UNITED STATES PATENT AND TRADEMARK OFFICE

Office Action Summary	Application No. 10/790,917	Applicant(s) CANTRELL, MARTIN B.	
	Examiner Christine T. Cajilig	Art Unit 3637

DETAILED ACTION

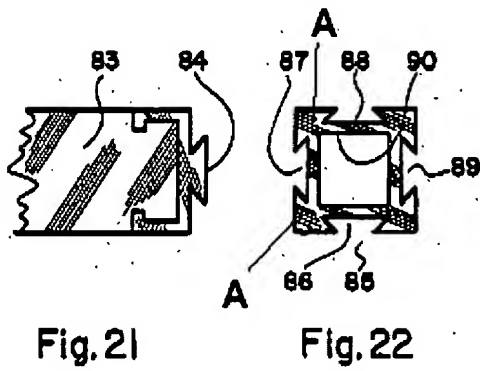
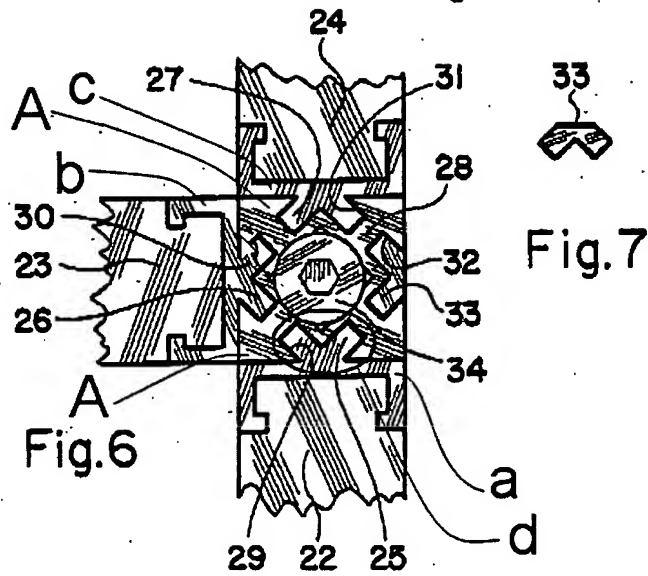
Regarding claims 11-12, Lew in Figures 21 and 22 discloses a mortise comprised of two separate first members (A) form a mortise (87) configured to receive a tenon (84). The mortise (87) is a female dovetail slot and the tenon (84) is a male dovetail. The phrase of "when said members are pushed together" is regarded to as functional language, and while features of an apparatus may be recited either structurally or functionally, claims directed to an apparatus must be distinguished from the prior art in terms of structure rather than function. Examiner refers Applicant to MPEP §2114. Furthermore, the structure of Lew is capable of performing the functions stated above and when the members (A) are pushed together, the members would act to further clamp the tenon that is captured in the mortise.

Regarding claim 13, Lew further discloses that said mortise and tenon joint is comprised of two separate members (A) configured to receive a tenon, said mortise capturing said tenon. The phrase of "when said members are pushed together" is regarded to as functional language, and while features of an apparatus may be recited either structurally or functionally, claims directed to an apparatus must be distinguished from the prior art in terms of structure rather than function. Examiner refers Applicant to MPEP §2114. Furthermore, the structure of Lew is capable of performing the functions

stated above and when the members (A) are pushed together, the members would act to further clamp the tenon that is captured in the mortise.
